VIRGINIA ELECTRIC AND POWER COMPANY
RICHMOND, VIRGINIA 23261

November 7, 2022

VIRGINIA ELECTRIC AND POWER COMPANY (DOMINION ENERGY VIRGINIA)
NORTH ANNA POWER STATION UNITS 1 AND 2
SURRY POWER STATION UNITS 1 AND 2
PROPOSED LICENSE AMENDMENT REQUEST TO
REVISE EMERGENCY PLAN STAFF AUGMENTATION TIMES

FOLLOWING CERC ACTIVATION
FIGURE 5.24

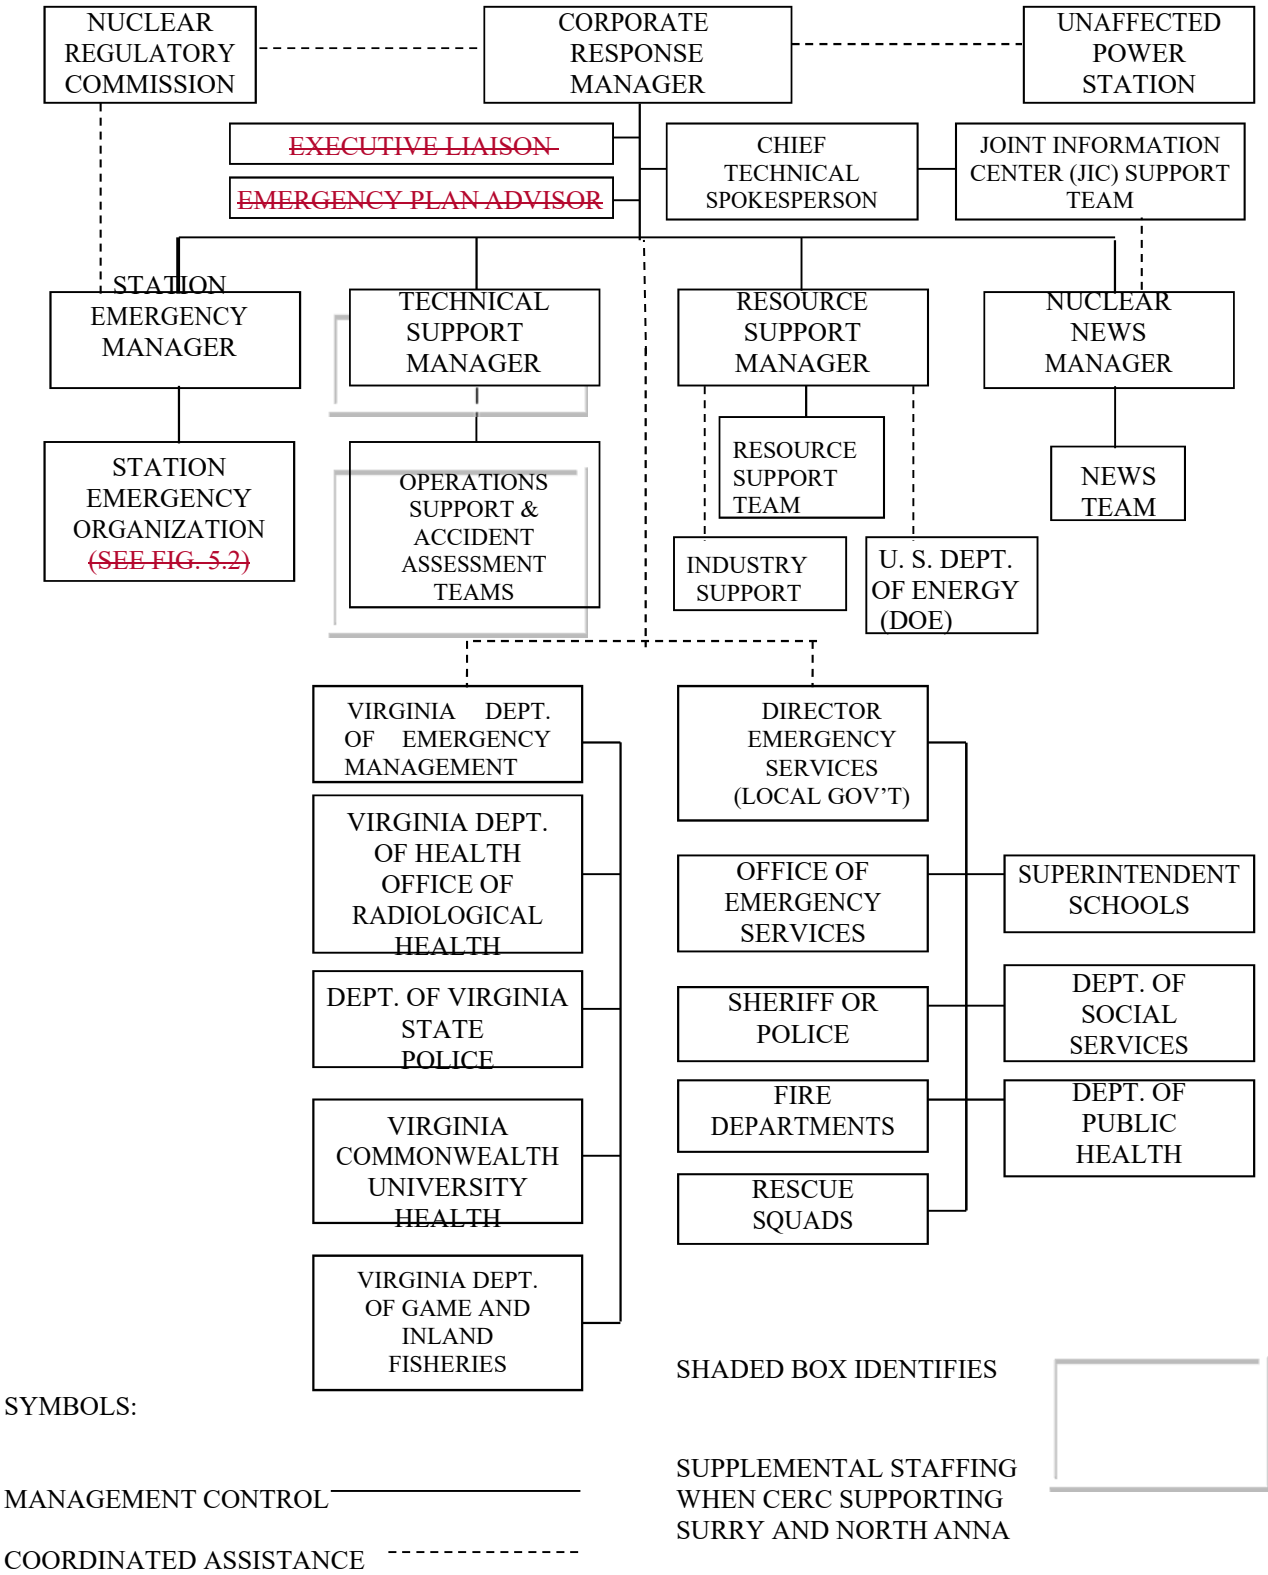
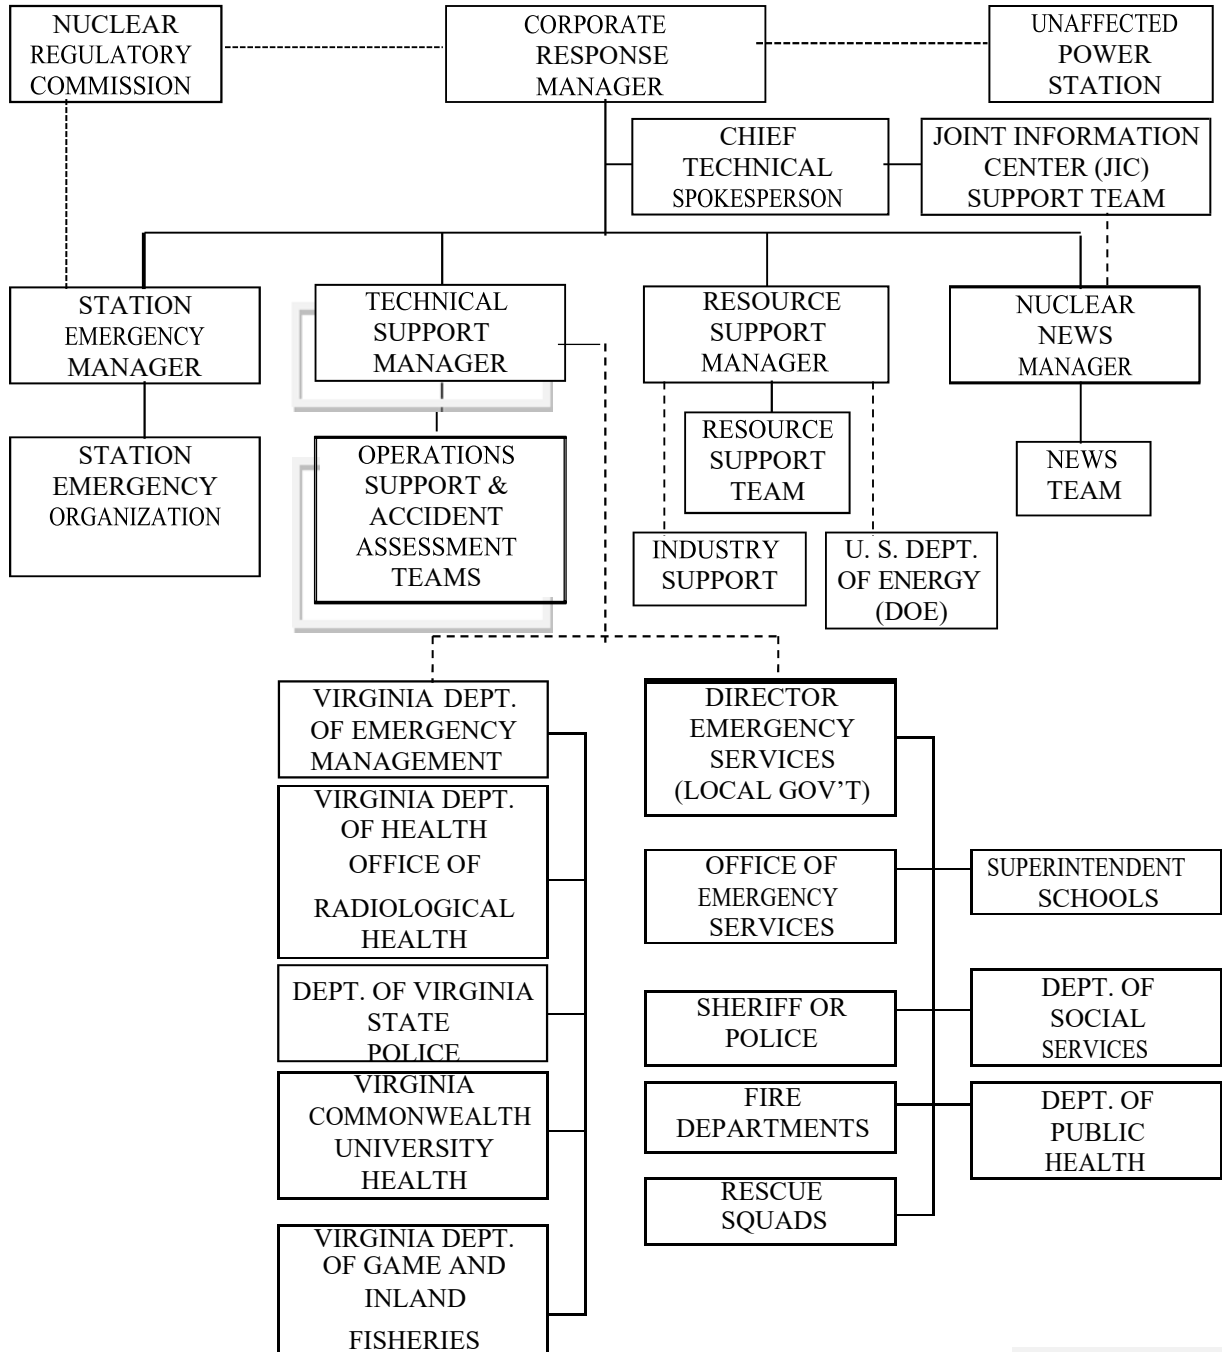
- ss. Figure 5.4, "Station to Support Group Interface Following CERC Activation," renumbered section and revised to reflect new numbering, removal of admin/support positions, and new facility organization chart numbering.

FIGURE 5.35-a

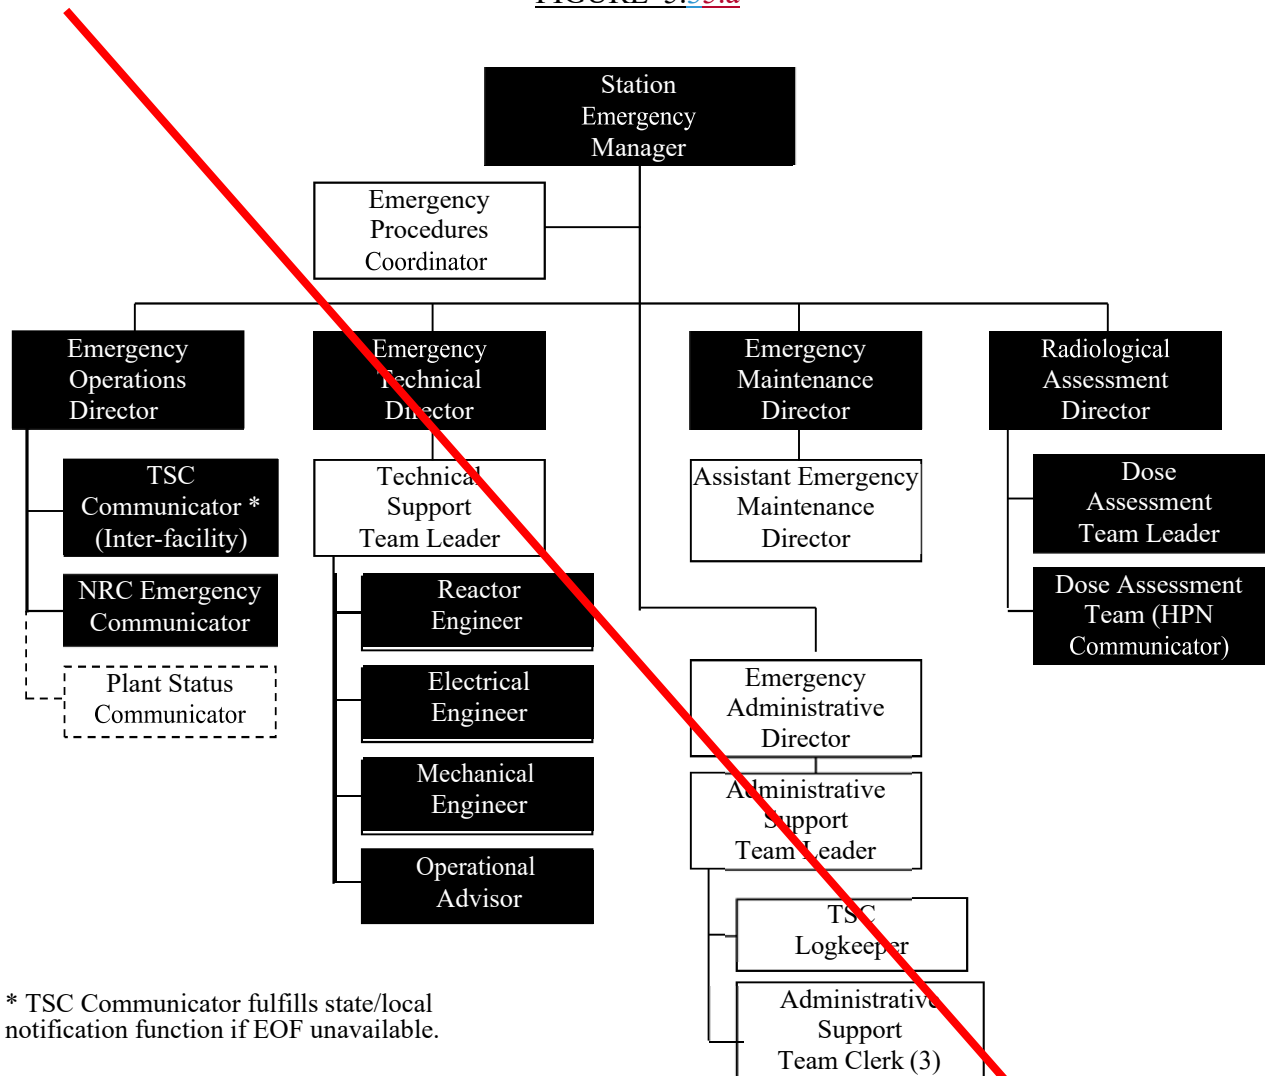
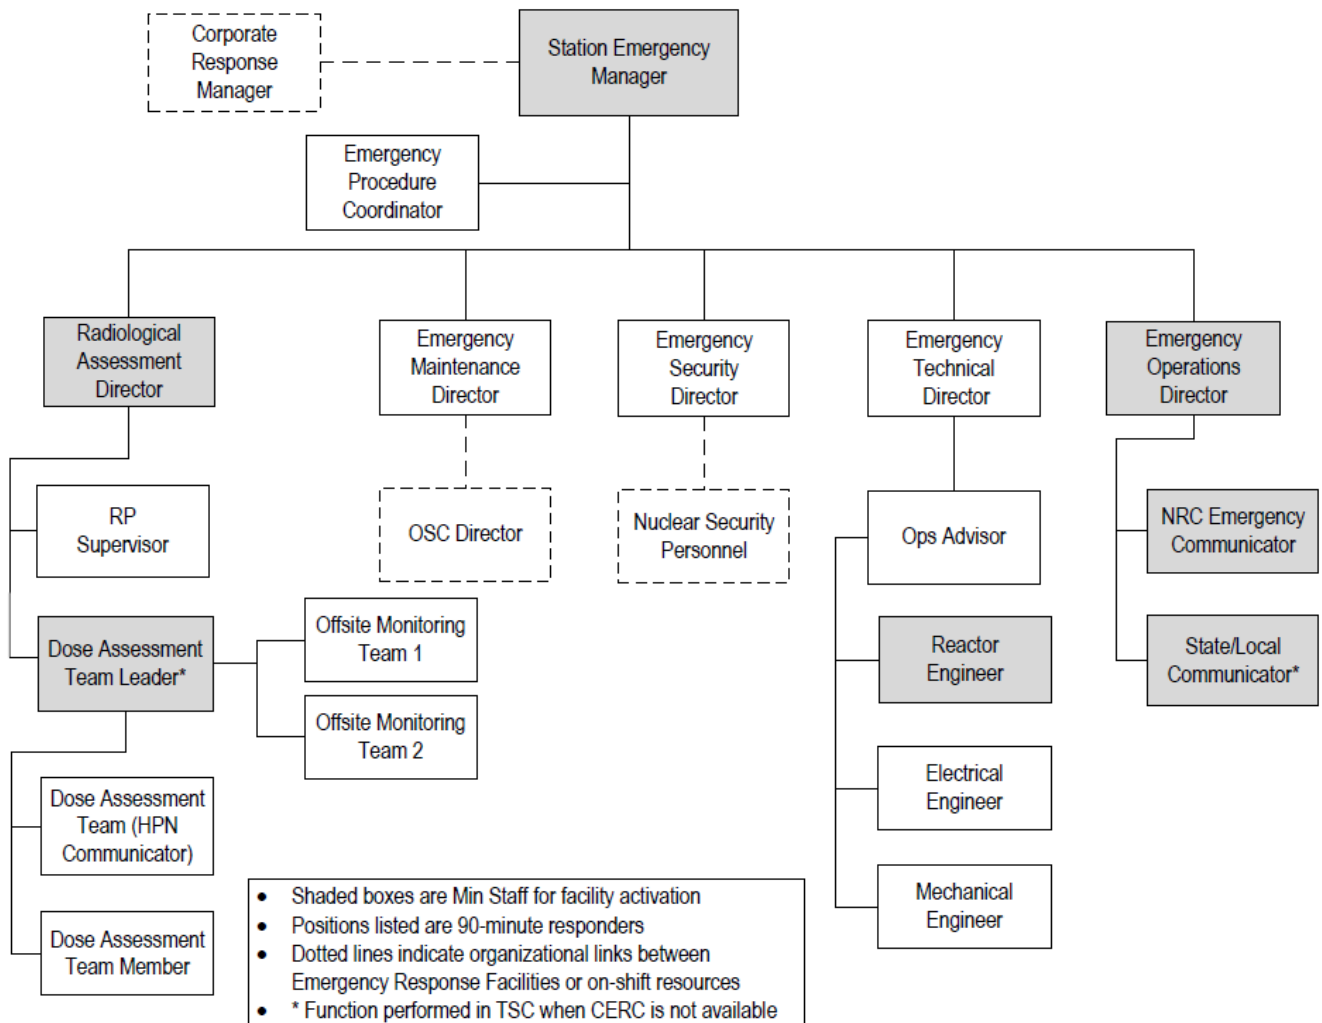
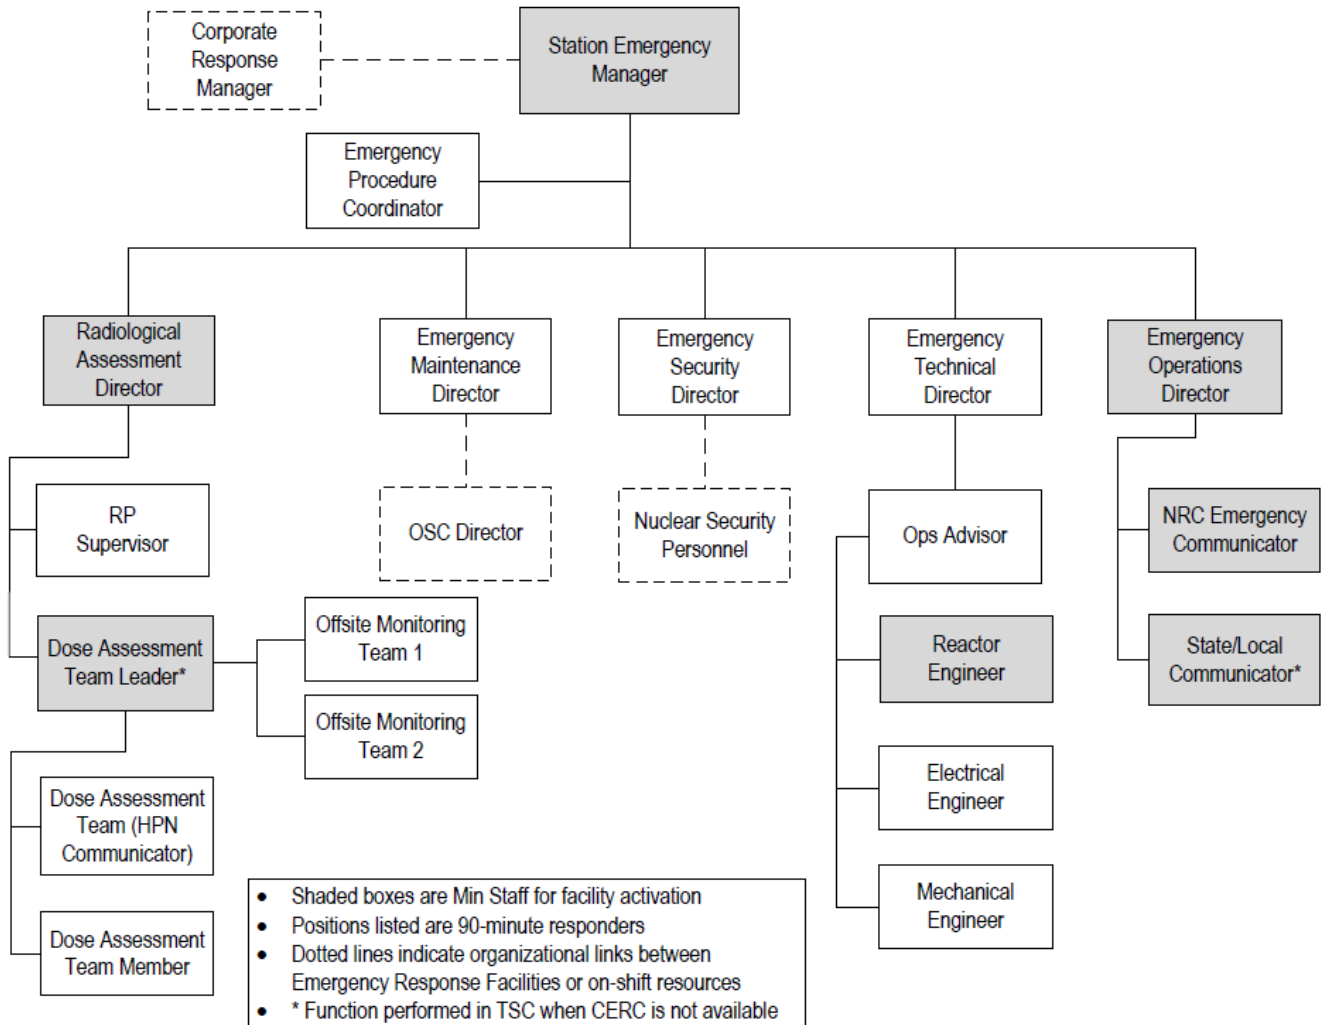
- tt. Figure 5.5.a, "Technical Support Center Organization," renumbered section and revised to reflect proposed staffing and positions required for facility activation.
